APPLICATION NO.	FILING DATE	FIRST NAMED INVENTOR	ATTORNEY DOCKET NO.	CONFIRMATION NO.
10/600,461	06/23/2003	Lorenzo Cortelazzo	37647/GM/br	7264
7590 MODIANO & ASSOCIATI Via Meravigli, 16 Milano, 20123 ITALY		02/08/2007	EXAMINER NAGPAUL, JYOTI	
			ART UNIT 1743	PAPER NUMBER
SHORTENED STATUTORY PERIOD OF RESPONSE 3 MONTHS		MAIL DATE 02/08/2007	DELIVERY MODE PAPER

Office Action Summary	Application No.	Applicant(s)	
	10/600,461	CORTELAZZO, LORENZO	
	Examiner	Art Unit	
	Jyoti Nagpaul	1743

DETAILED ACTION

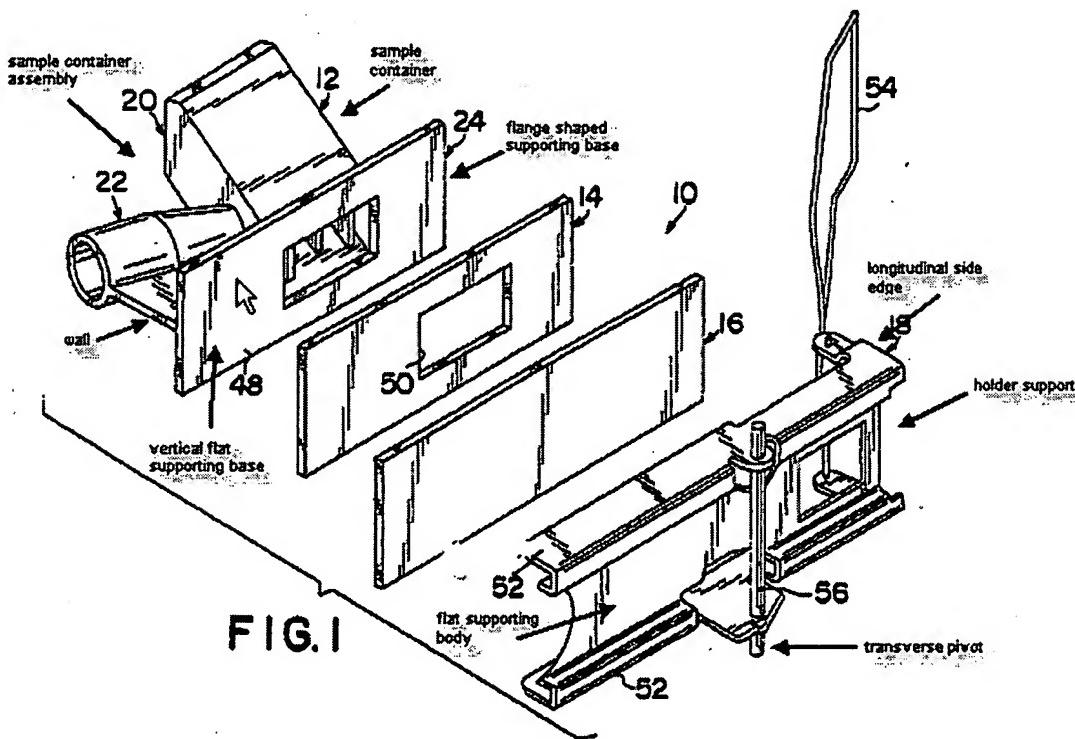
Hayes teaches a sample container assembly in centrifuges. The assembly comprises a holder support and the sample container assembly, respectively, being made independent from each other and detachably connectable in use. The sample container (12) assembly being a unitary plastic body comprising a sample container with a vertical flat flange shaped supporting base (24) suitable for insertion in the holder support for supporting the sample container in an upright position upon mounting

thereon in the cyt centrifuge, a slide, and a filtering card (See Col. 5, Lines 19-21) (See Figures 1 and 5). Hayes teaches a transverse pivot protruding from the supporting body and made monolithic therewith for fixing the support to the cyt centrifuge. (See figure below)

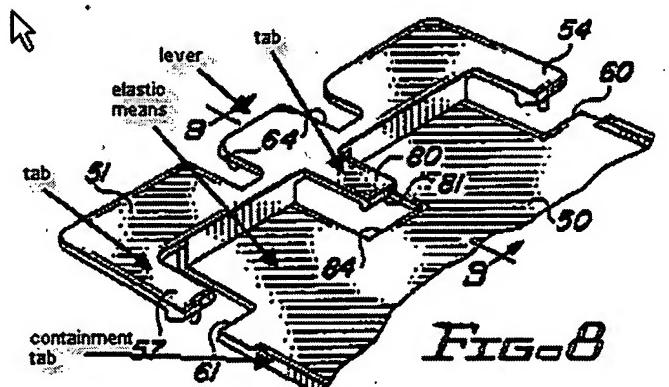
Merrick teaches clamp means formed on the edges and at least one perpendicular containment tab formed on the lower edge, the clamp means and containment tab made monolithic with the flat supporting body of the holder support.

Merrick further teaches elastic means for taking up, upon accommodation of the slide, filtering card and container base, mounting plays, the elastic means being made integral with the supporting body in a region where the slide rests. Merrick further teaches clamp means are constituted by two mutually opposite hook-shaped tabs, which are sized so as to retain between ends thereof and the supporting body the slide, the filtering car and the supporting base of the container, the hook shaped tabs comprising respective levers that extend towards a rear part of the supporting body. (See Figure below)
